Access Compliance Report Public Rights-of-Way (Curb Ramps)

Main Street: CARTLEN_DR Cross Street: HAMER_DR Location: NW

ADA ID: RPRK210917152944 Ramp Type: Type 1 - Perpendicular Initial Pass/Fail: Pass Overall Compliance: No Severity Score: 16

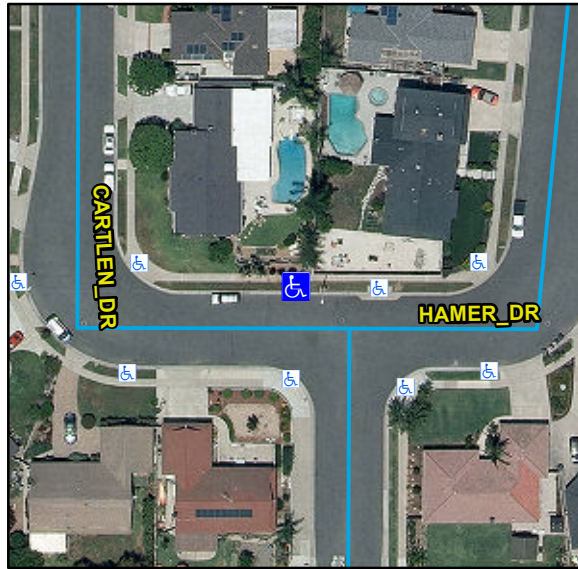
R304.2.2, R304.2.1, R305, R302.7, R304.5.3, STD 1115

Remove & Replace Entire Ramp. Remove & Replace Gutter.
